ADDENDUM NO.03 DATE: 11/03/21

PROJECT:
'Matilda Torres High School, Toros Stadium'
Matilda Torres High School
16645 Road 26. Madera, CA 93638

The following additions, deletions, and revisions to the SHEETS and Project Manual are hereby made and do become a part of these Contract Documents.

BUILDINGS M1, M2
ROOF PLAN AND REFLECTED CEILING PLAN
Drawing

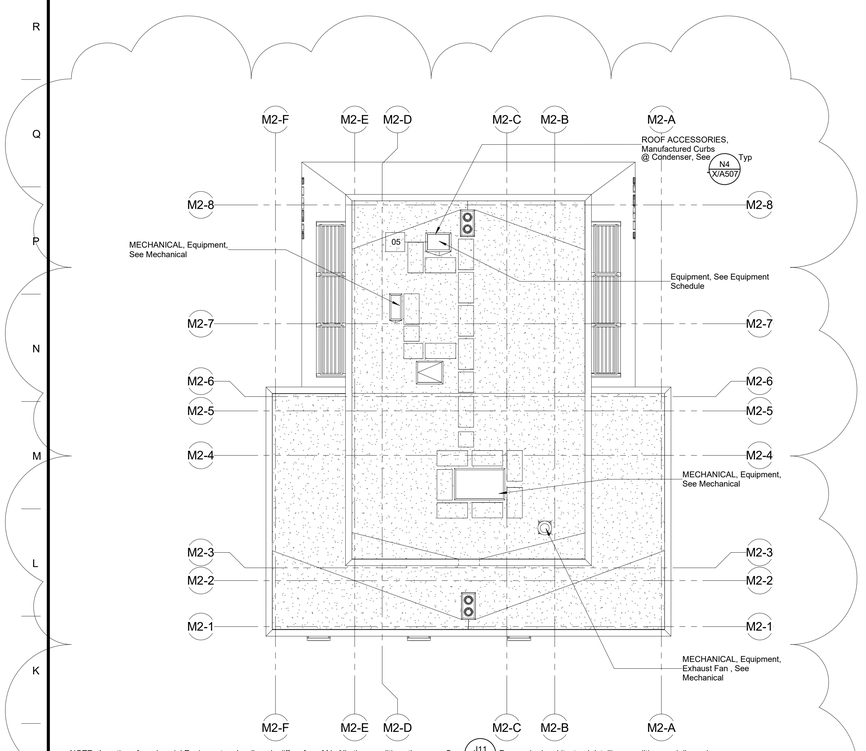
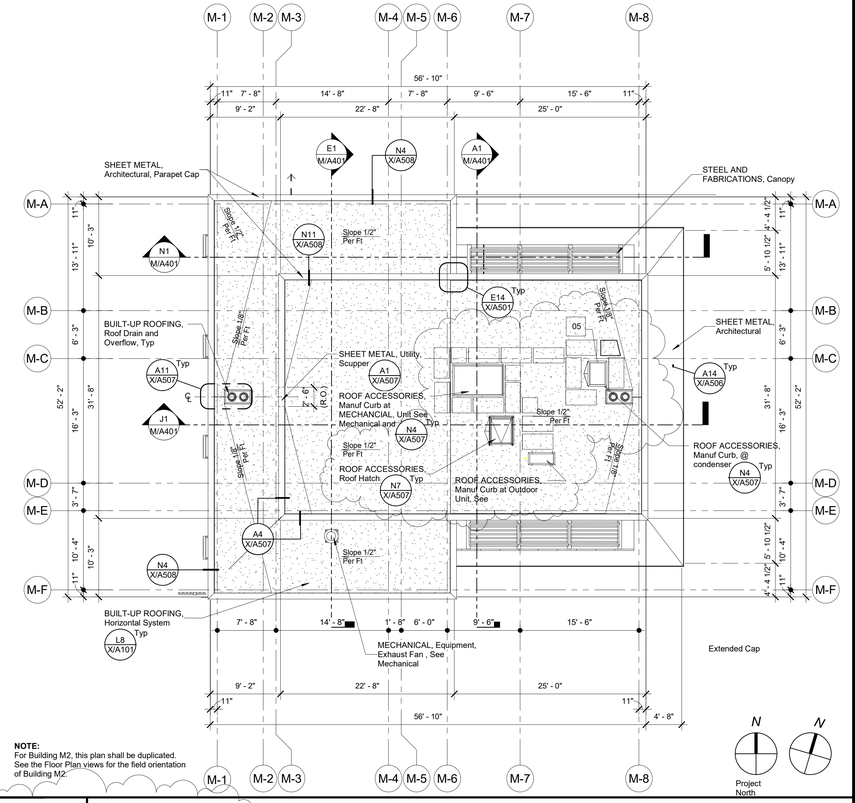
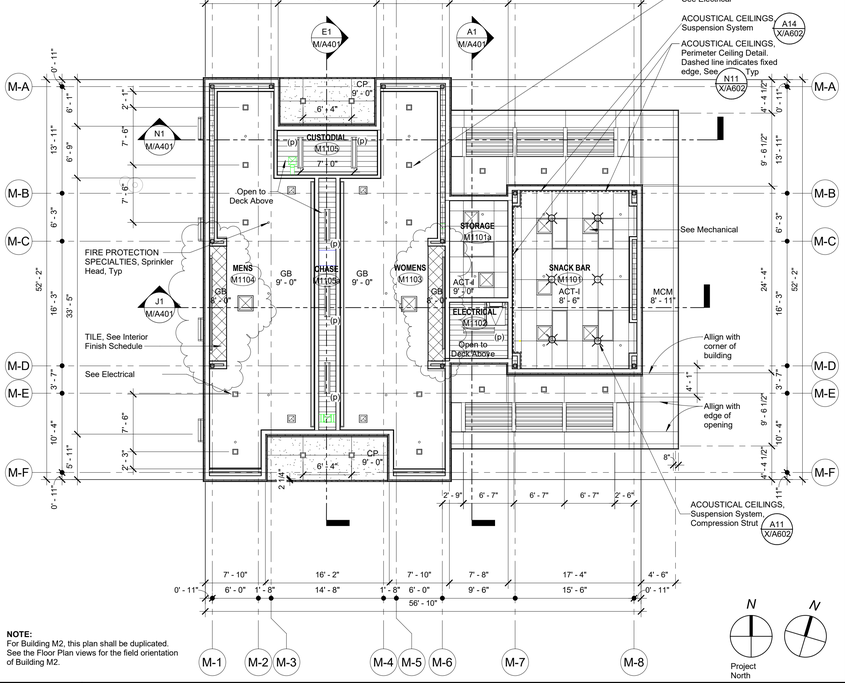
AD3-A01 Refer to Sheet M/A201 Replace Sheet with Attached drawing AD3-AX01

1. See added Roof Plan J1
a. Roof plan for Building M2 added

2. See Roof Plan J11
a. Roof plan updated to show Split system ODU
b. Walk pad locations revised

3. See Ceiling Plan A11
a. Hatch added clarifying Tile finish at restroom soffits over sinks

AD3-AX01

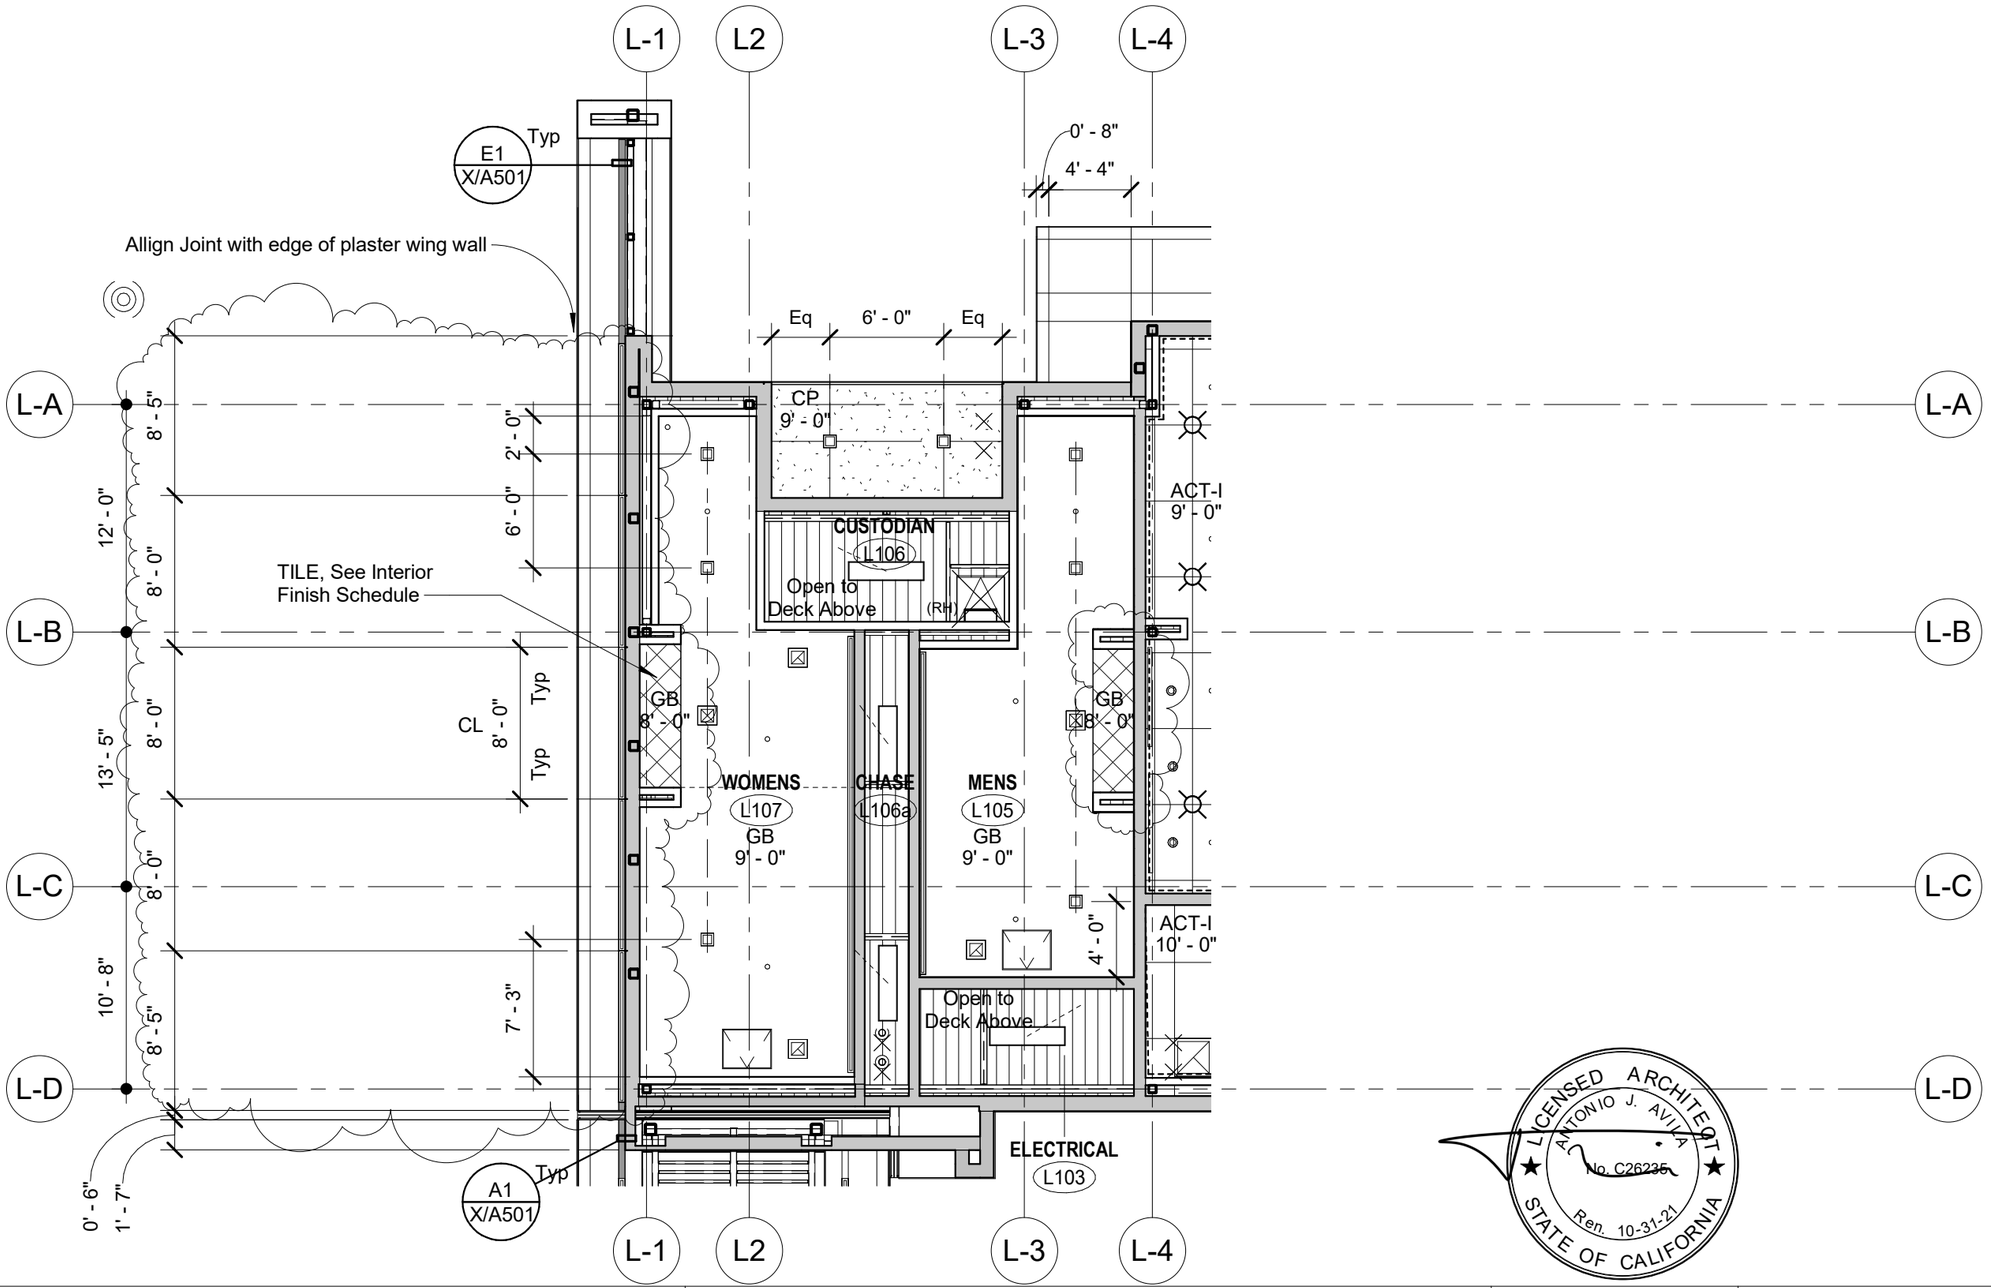
AD3-A02 Refer to Sheet L/A201. Replace portion of Ceiling plan A1 with attached drawing AD3-AX02
1. Hatch added clarifying Tile at restroom soffits
2. Lighting at exterior soffit coordinated with electrical drawings. Detailing revised

See L/A601Room 105 EAST

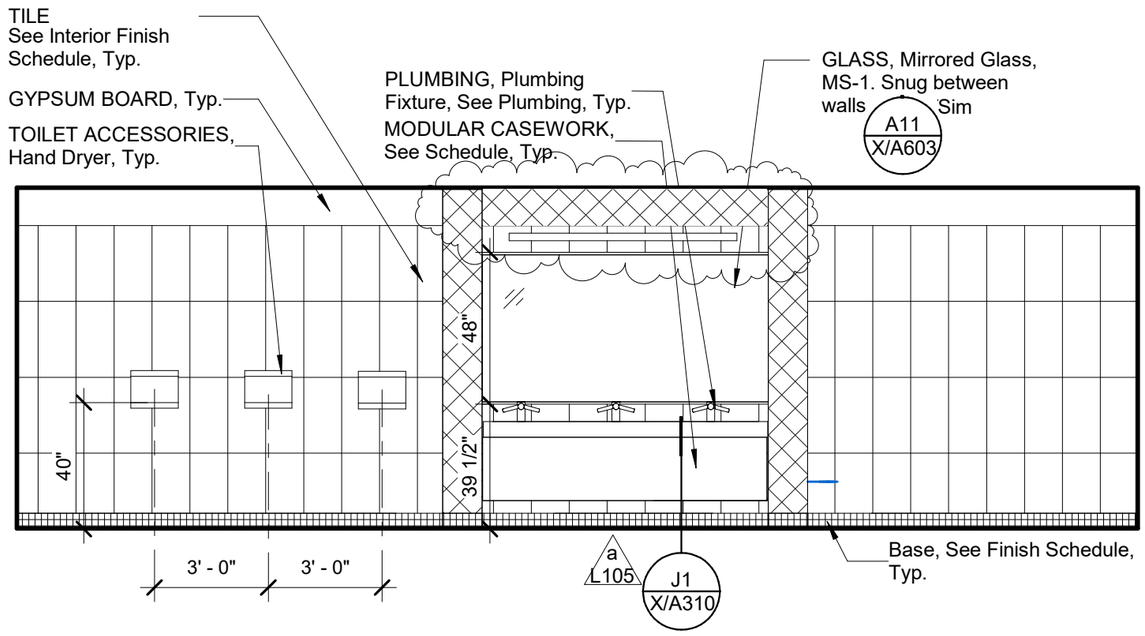
AD3-A03 Refer to sheet L/A60, Replace EAST elevation of room 105 'MENS' with attached drawing AD3-AX03
1. Hatch added clarifying Tile above sinks.

AD3-AX04

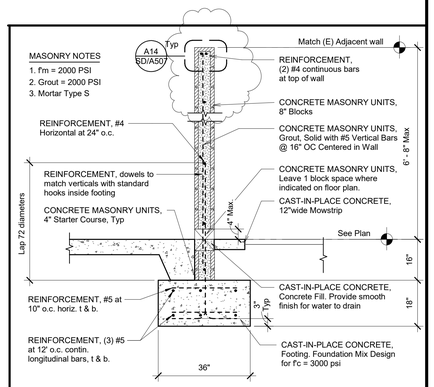
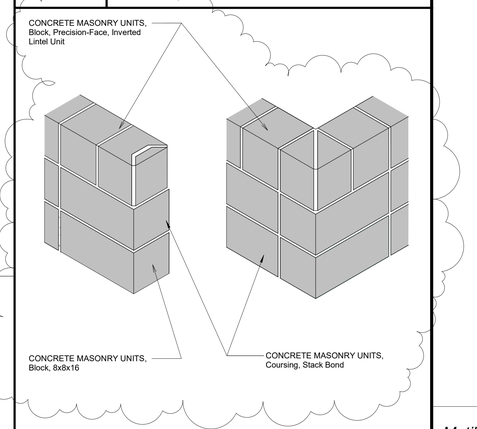
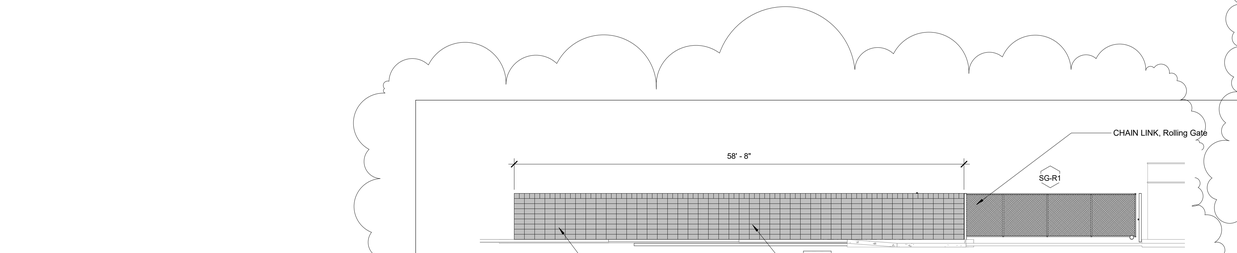
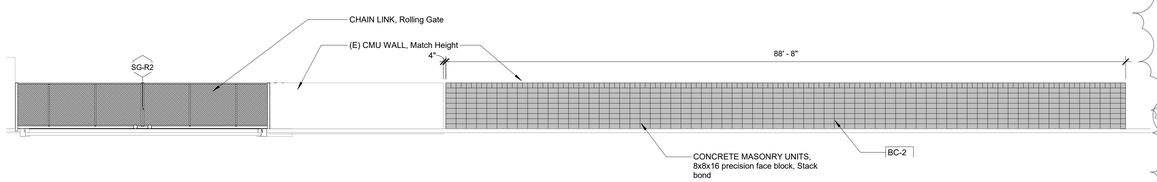
AD3-A04 Refer to Sheet SD/A507, replace sheet with attached drawing AD3-AX04
1. Refer to Detail J14 (formerly identified as J4)
a. Hatching updated to clarify CMU coursing

2. Refer to detail A14 (formerly identified as A4)
a. Hatching revised to clarify coursing and block type.
b. Detail updated to accurately reflect lintel course requirements

3. Elevations A5, D7 added to clarify site wall coursing and pattern requirements

AD3-AX05

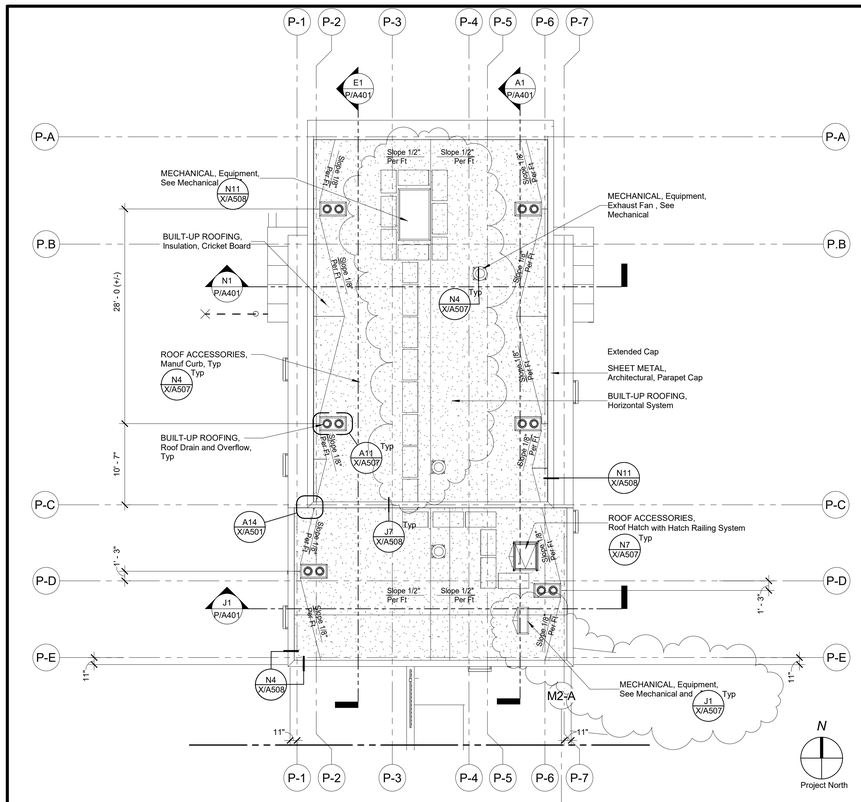
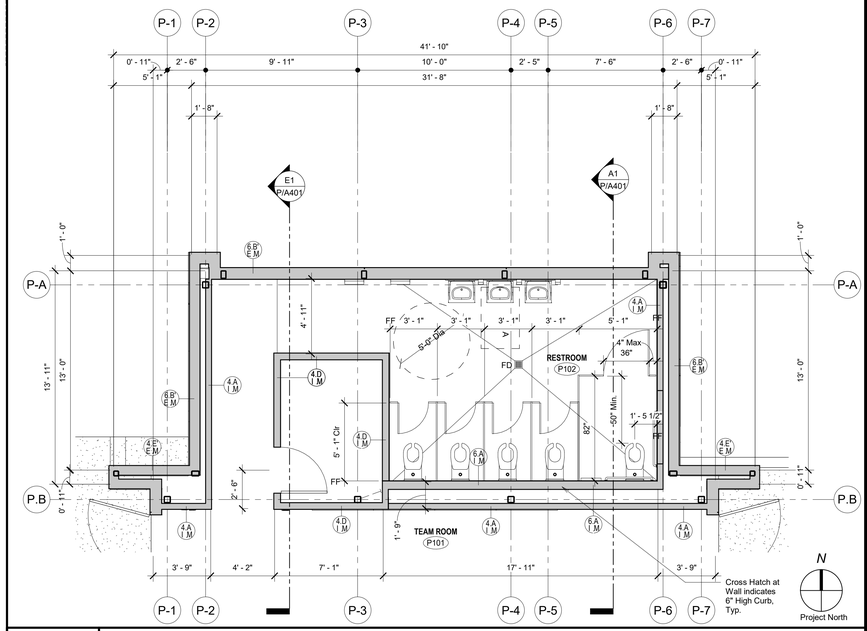
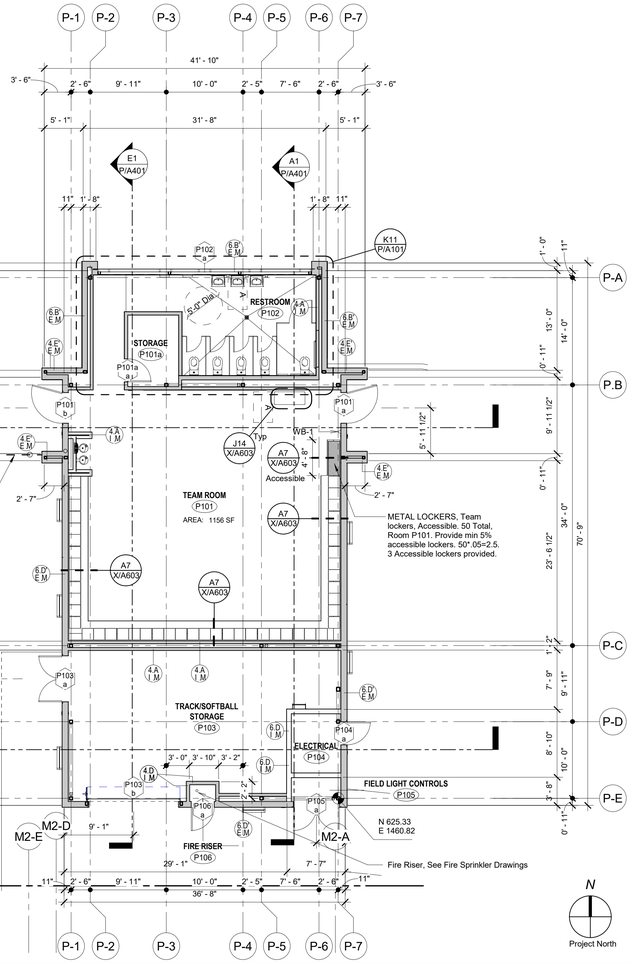
AD3-A05 Refer to Sheet P/A101. Replace with attached drawing AD3-AX05

1. Roof plan revised to coordinate mechanical unit locations.
    a. Package unit and walk pads shifted to the north, additional walk pads added
    b. ODU unit indicated on roof plan to coordinate with mechanical

AD3-AX06

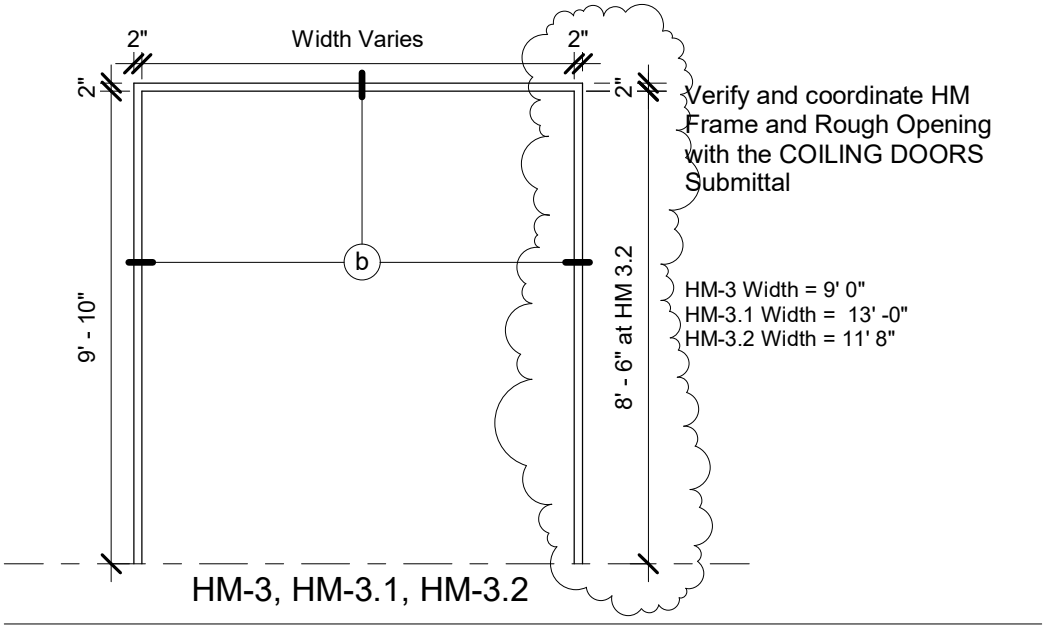
AD3-A06 Refer to Sheet X/A402, Refer to detail E10

1. Replace HM3 frame elevation with attached drawing AD3-AX06
    a. Elevation added to clarify height of HM3.2

BUILDING Q
EXTERIOR RAINSCREEN DETAILS
Drawing

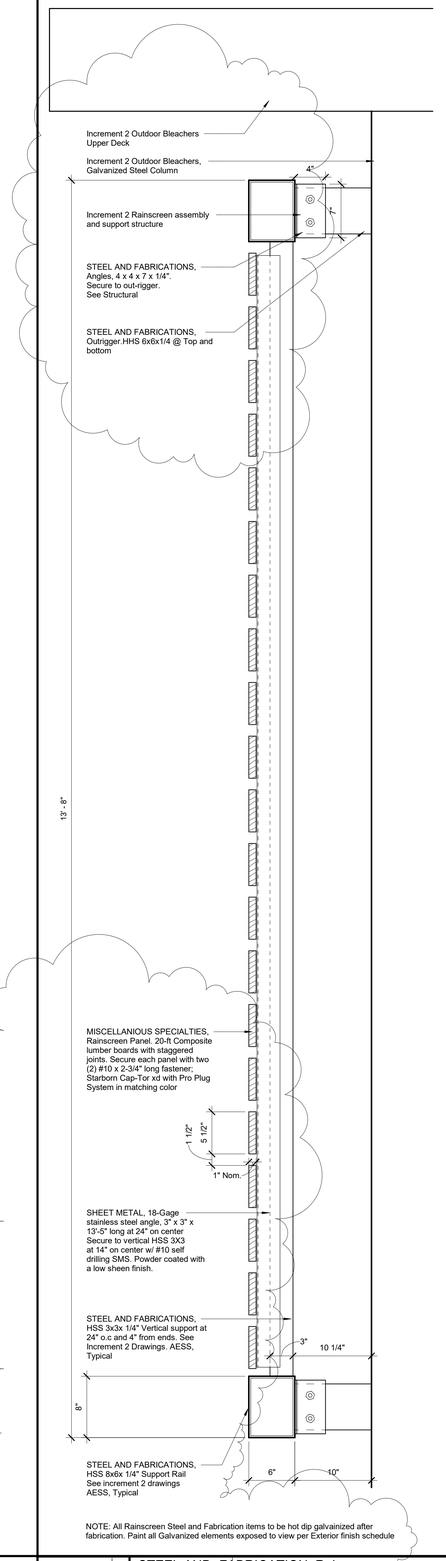
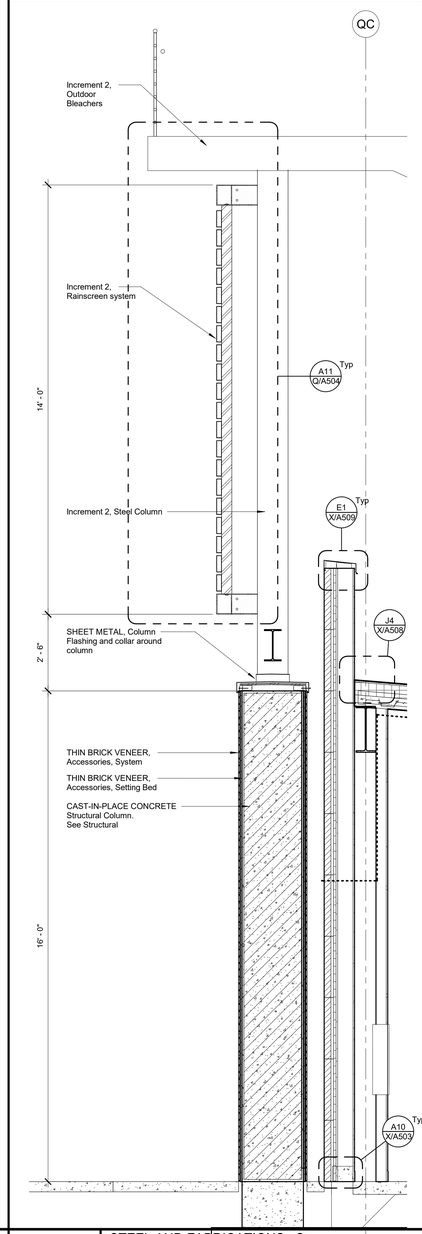
AD3-A08 Refer to Sheet Q/A504

1. Replace Sheet with attached drawing AD3-AX07
    a. Notes modified to clarify Steel and Fabrication member sizes for rainscreen
